**TOWN OF LAKE PARK  
SPECIAL CALL  
HISTORIC PRESERVATION BOARD  
MEETING AGENDA  
JULY 9, 2018  
6:30 P.M.  
535 PARK AVENUE  
LAKE PARK, FLORIDA**

- 1. SPECIAL CERTIFICATE OF APPROPRIATENESS FOR EXTERIOR IMPROVEMENTS (CANOPY AND FRAME; PATIO/PLAZA WITH SEATING AND APPURTENANCES; EXTERIOR SIGNAGE AND WALL LIGHTING) TO THE 918 PARK AVENUE BUILDING, A HISTORICALLY DESIGNATED BUILDING. APPLICANT: COVENTINA BUILDERS, LLC., ON BEHALF OF M&S SANTOS, LLC, OWNER**

**TOWN LAKE OF PARK**  
**SPECIAL CALL PLANNING & ZONING BOARD MEETING**  
**SPECIAL CALL HISTORIC PRESERVATION BOARD MEETING**  
**MEETING DATE: July 9, 2018, 6:30 P.M.**

**MEMORANDUM DATE:** September 1, 2017/ Revised Nov. 20, 2017 / Amended June 26<sup>th</sup>, 2018

**PROPOSED SITE PLAN**

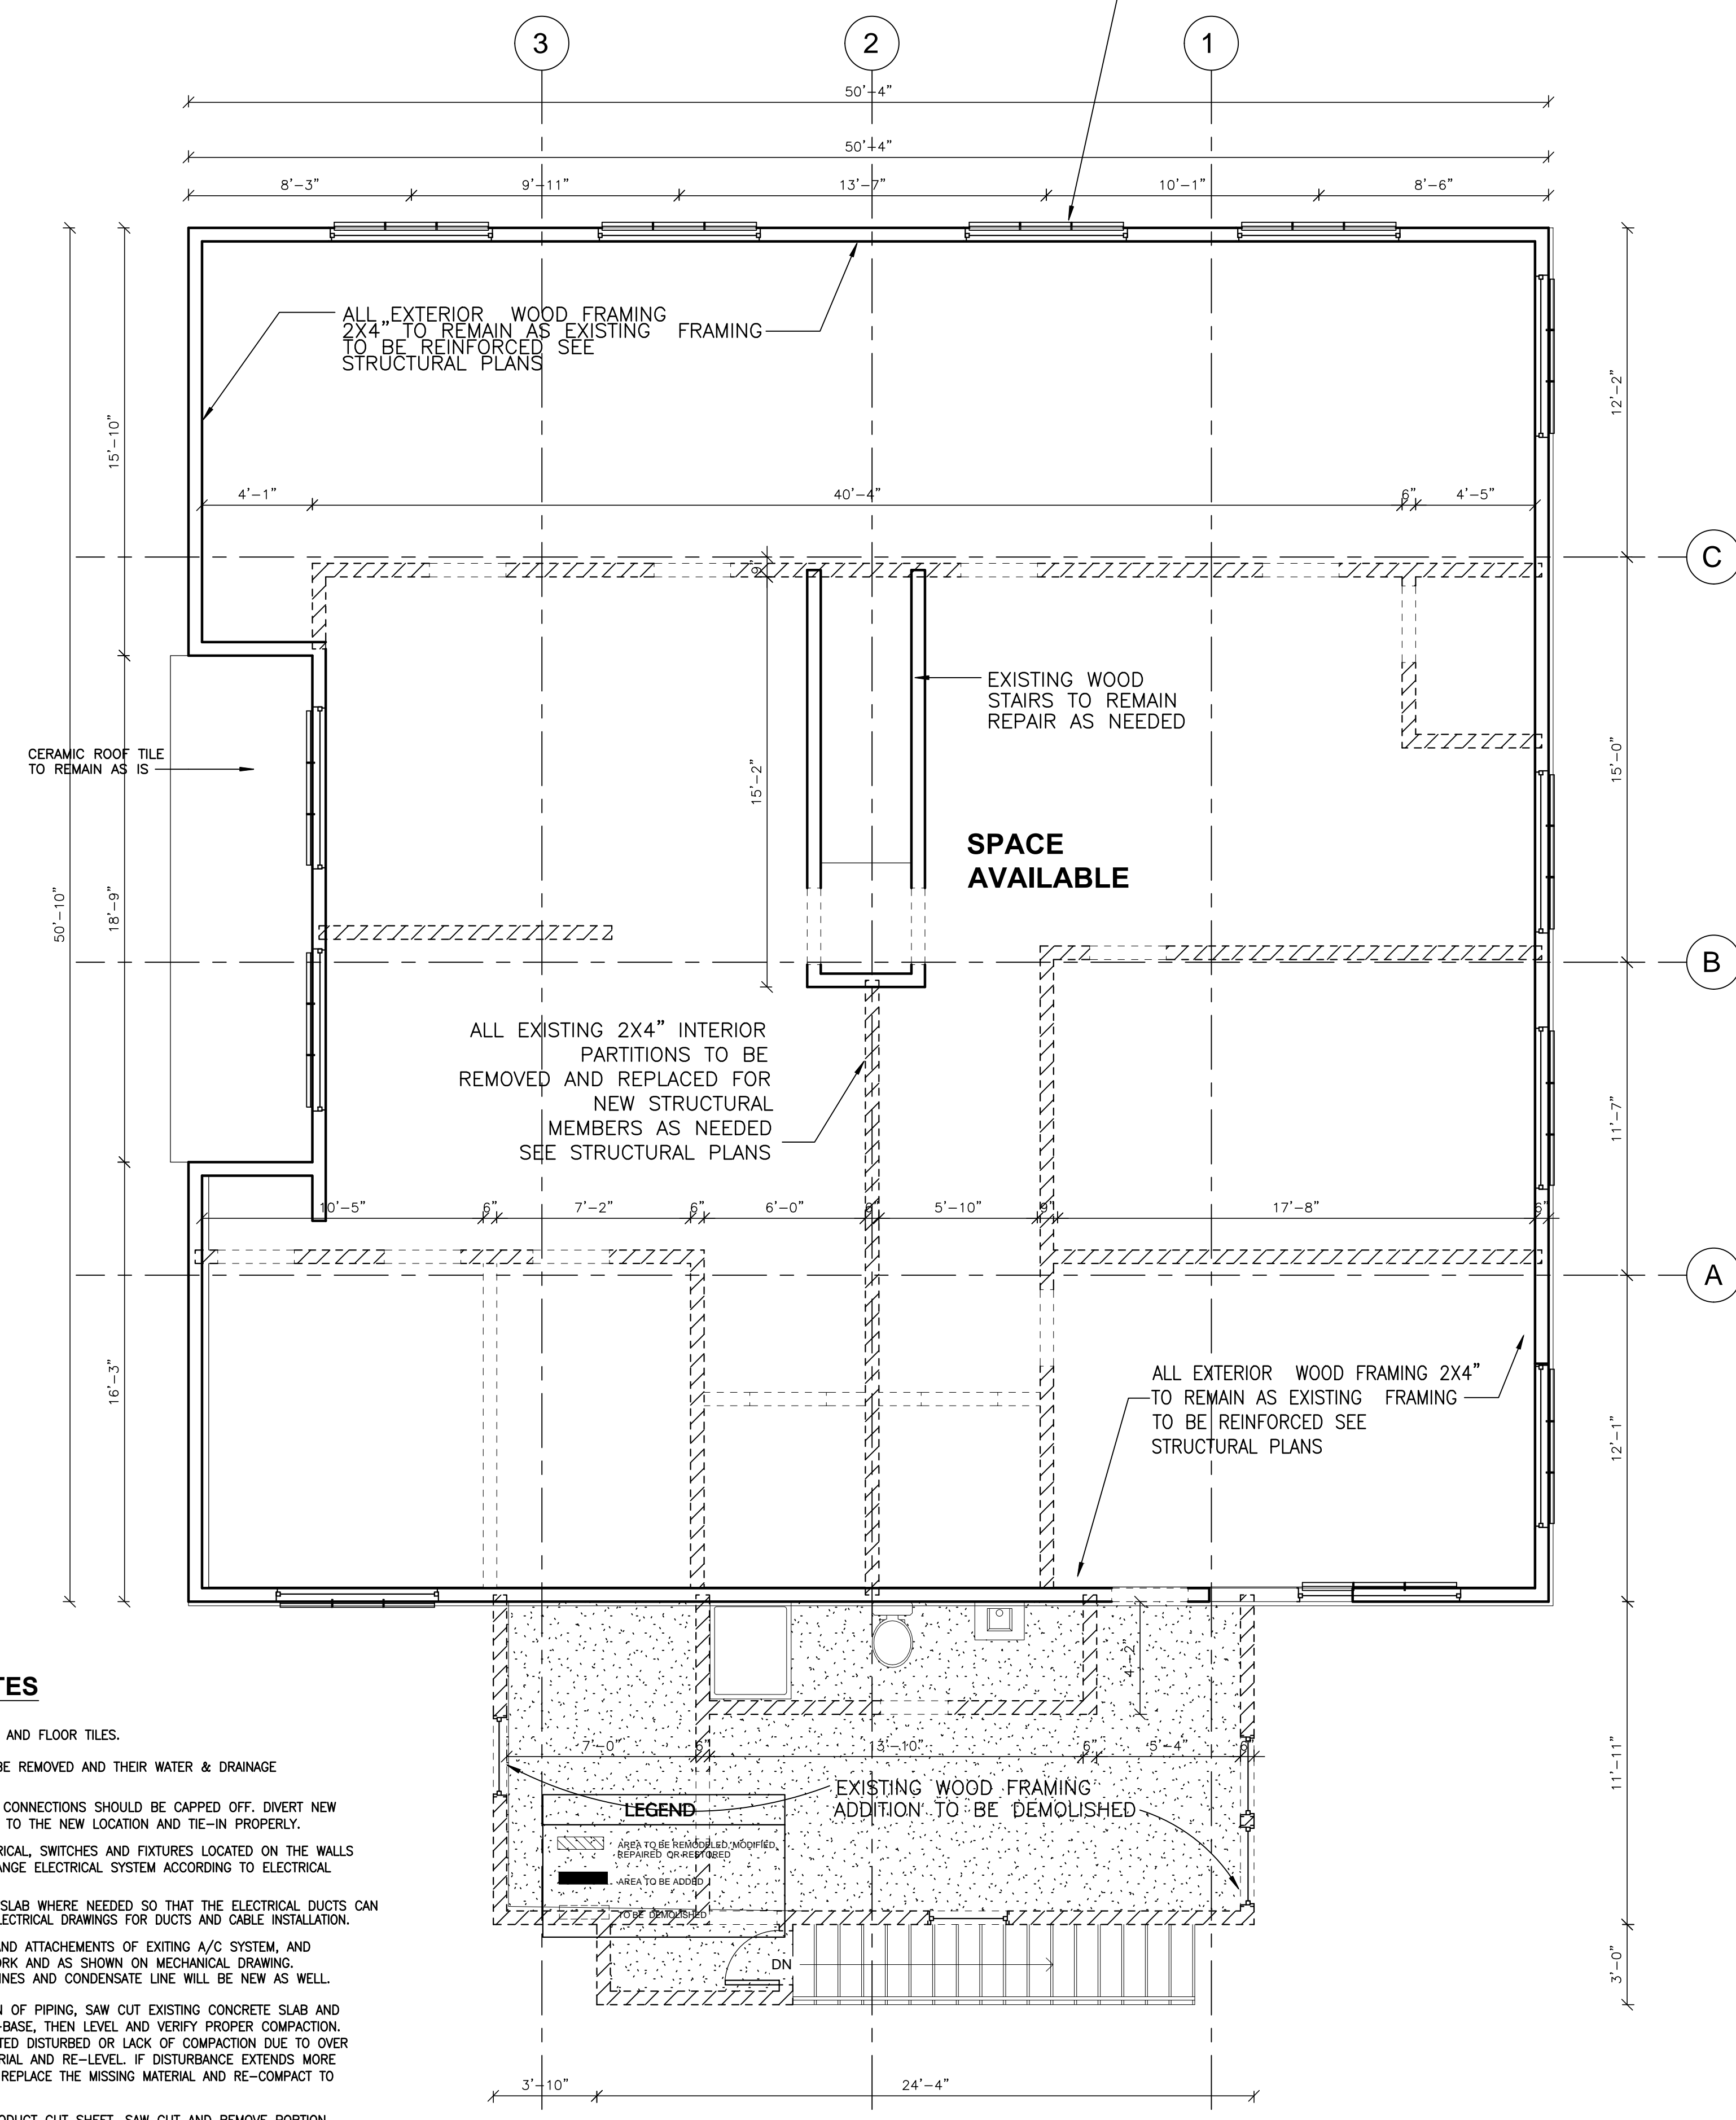
1. Sheet A101.1 Site Plan – Site plan shows a patio added to the east side of the building and located at the north eastern portion of the site.
2. Sheet A108 Sign Plan Proposed – This sheet shows location of proposed signage and wall pack lighting.
3. Sheet A111 Entry Canopy Option 3d Views – This sheet shows the patio/plaza, proposed east entry canopy, exterior furnishings (not reviewed) and appurtenances (not reviewed).

- A patio/plaza has been added to the east side of the building. *Amendment – This ground level patio/plaza appears to provide minimal impact to the site and no impact to the building*

**PROPOSED EAST ELEVATION**  
 SCALE: 1/4" = 1'-0"

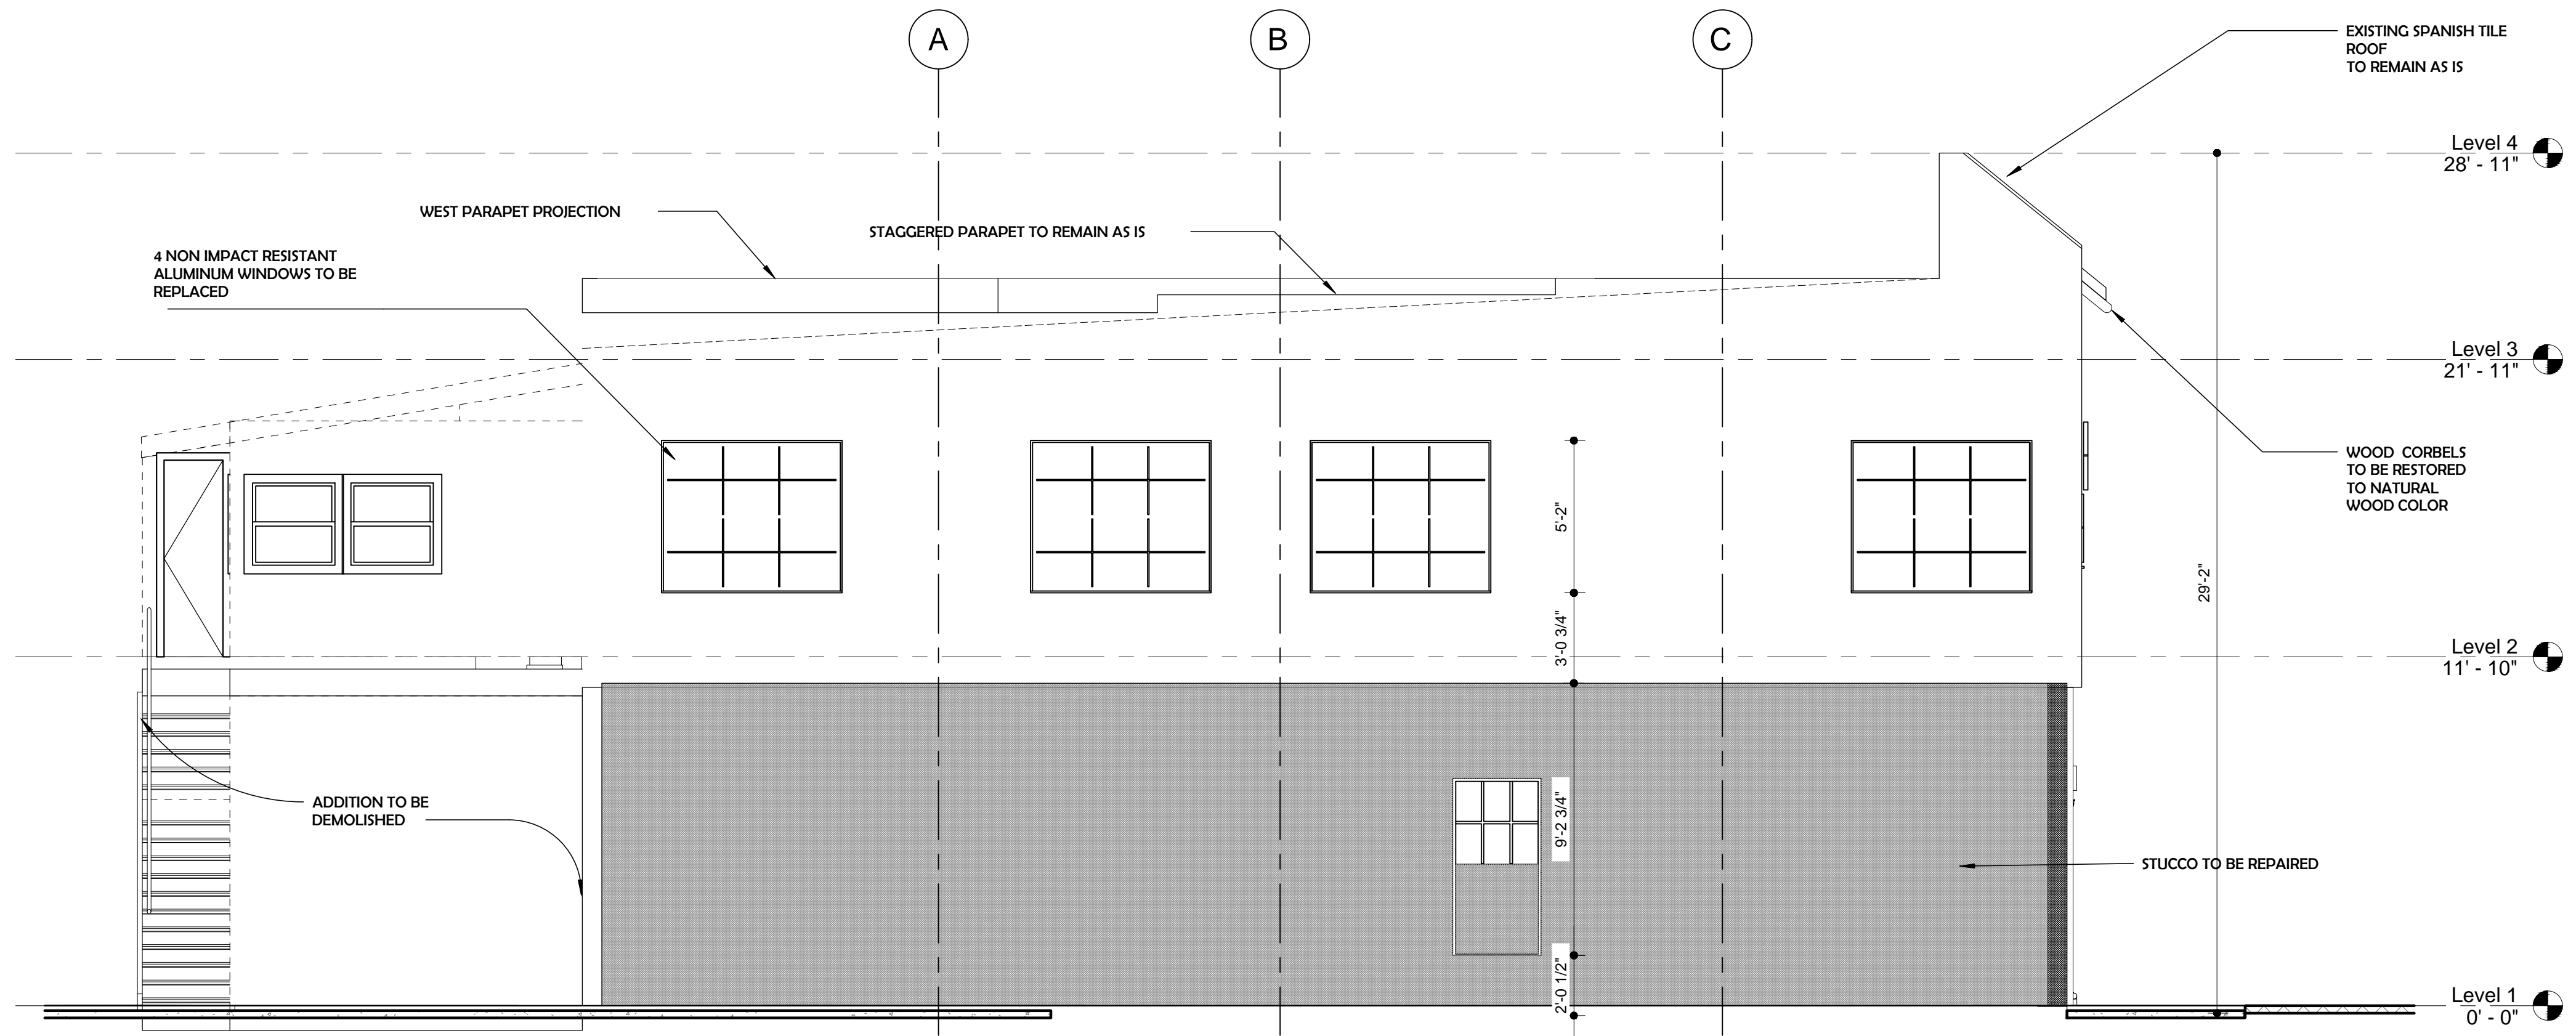
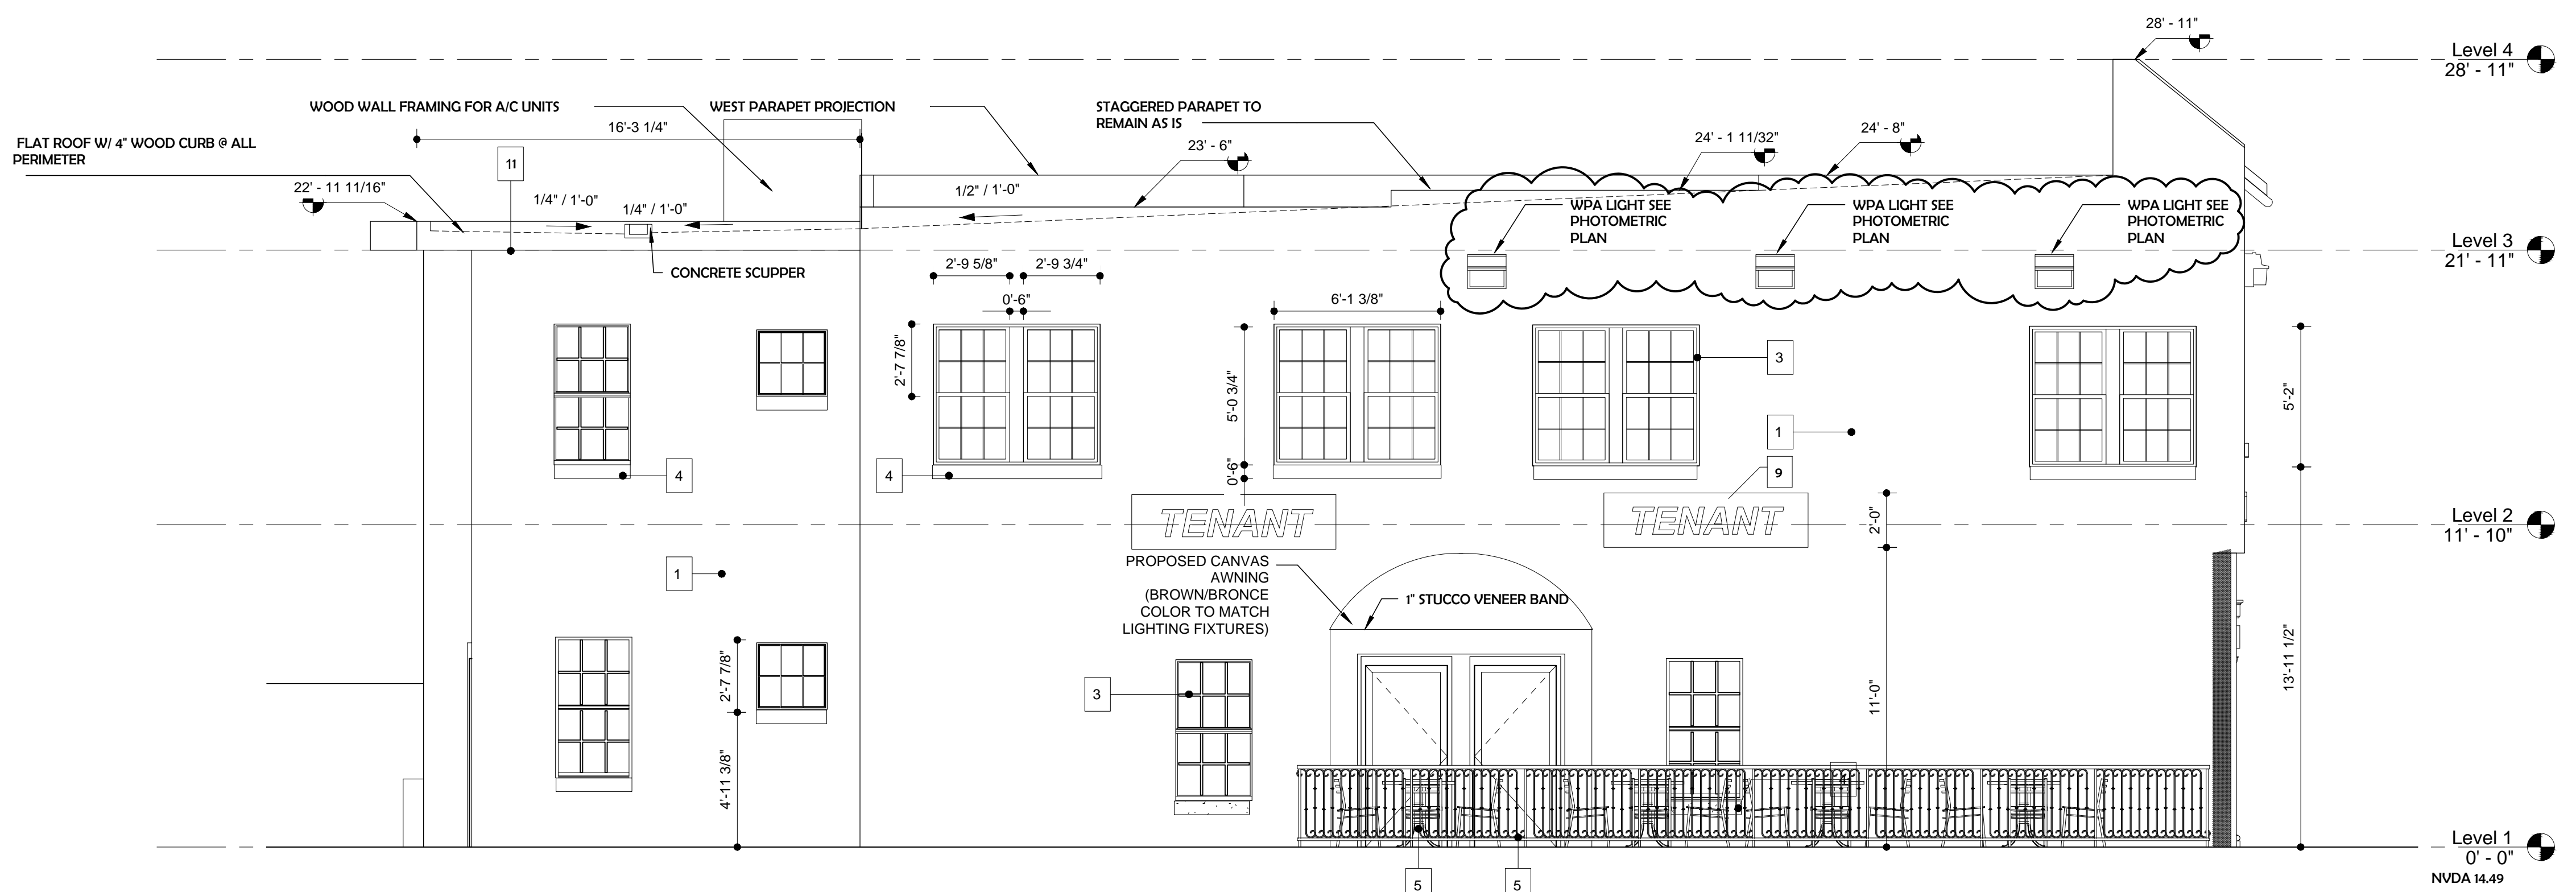
- Alterations add second entrance to East side entrance that competes in scale to main street and traffic flow – *Action: Remove the secondary entrance, there was not one there historically. If there is a requirement to have one it should very simple and be a single door with a historically compatible awning – it needs to not be competitive with the historic street and sidewalk entrance which is the most important historic feature of the building. An entrance on the east side of the should be avoided. Result- Applicant complies without removing doors, detail and recesses have been removed. Amendment – An awning has been added to these doors and appears to have minimal impact on the historic integrity of the building. This awning shall be cloth and its frame shall be removable with no damage to the existing building.*

- A) SIGNAGE: On north elevation is now centered to openings. No conduit or any other electrical device will be visible from the exterior.
- B) WALL PACK LIGHTING: Revised Photometric design and calculation was produced using one of the recommended wall packs.
- C) POWER, LV AND DATA: No conduit or any other electrical device will be visible from the exterior.
- D) AWNING: to be cloth with a removable frame so it can be removed with no damage to the building
